Office Action Summary	Application No. 10/733,717	Applicant(s) KENDRICK, DONALD W.	
	Examiner CHUKA C. NDUBIZU	Art Unit 3743

DETAILED ACTION

Claims 1 and 2 are rejected under 35 U.S.C. 102(b) as being anticipated by Stone 3,074,648. Stone teaches the invention as claimed (fig 1).

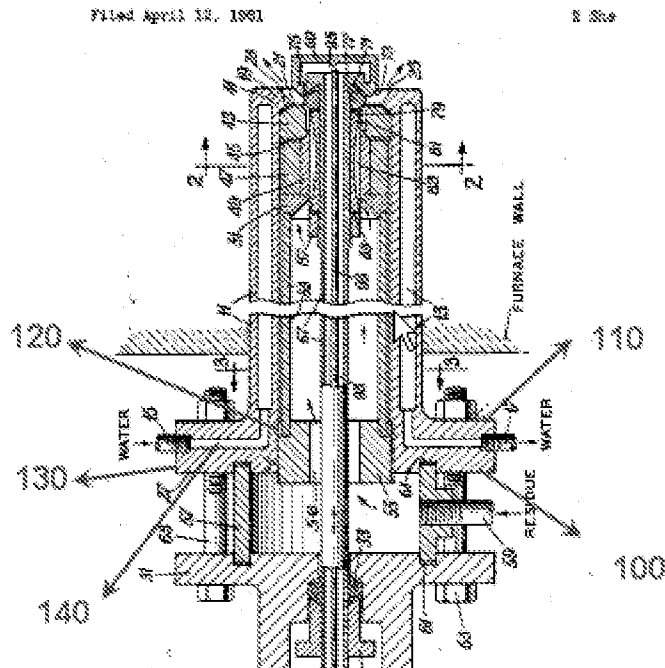
With regard to claim 1 Stone discloses **an apparatus comprising: a mounting flange 27 for coupling the apparatus to the upstream conduit 67 (see fig 1) and having: (see a reproduction of part of Stone's fig 1 below with additional labelling) upstream 100 and downstream 110 faces; an interior surface 120 bounding a central aperture; an outboard perimeter 130 having at least one cooling fluid inlet 15 ; at least one radially extending passageway through the flange 140 in communication with the at least one cooling fluid inlet 15; and an array of bolt holes between the upstream and downstream faces (where bolt 63 goes through on 27); a conduit 13, in communication with the at least one radially extending passageway, extending downstream from the flange (see fig 1) and having: inner and outer walls along at least a portion of a length (see fig 1); and a space 13**

between the inner and outer walls for carrying a cooling fluid, and a cooling fluid outlet 17.

With regard to claim 2 Stone also discloses **wherein the space extends from an upstream end outside the vessel wall at least partially downstream within the wall** (see fig 1).

With regard to claim 1 Stone (solving the same problem of cooling a nozzle in a furnace) teaches **a mounting flange 27 for coupling the apparatus to the upstream conduit 67** (see fig 1), (see part of Stone's fig 1 below) **having upstream 100 and downstream 110 faces; an interior surface 120 bounding a central aperture; an**

outboard perimeter 130 having at least one cooling fluid inlet 15 ; at least one radially extending passageway through the flange 140 in communication with the at least one cooling fluid inlet 15; and an array of bolt holes between the upstream and downstream faces (where bolt 63 goes through on 27).

With regard to claim 5 Stone also teaches the exterior surface (of tube 53) contacting the flange interior surface 120 (see fig 1).

With regard to claim 8 Stone also teaches a flange for mounting the nozzle 11 to an upstream conduit 67 (fig 1) wherein the flange includes at least one cooling fluid inlet 15 in communication with at least one passageway 140 extending radially inward therefrom to supply cooling flow (column 3 lines 67-68).
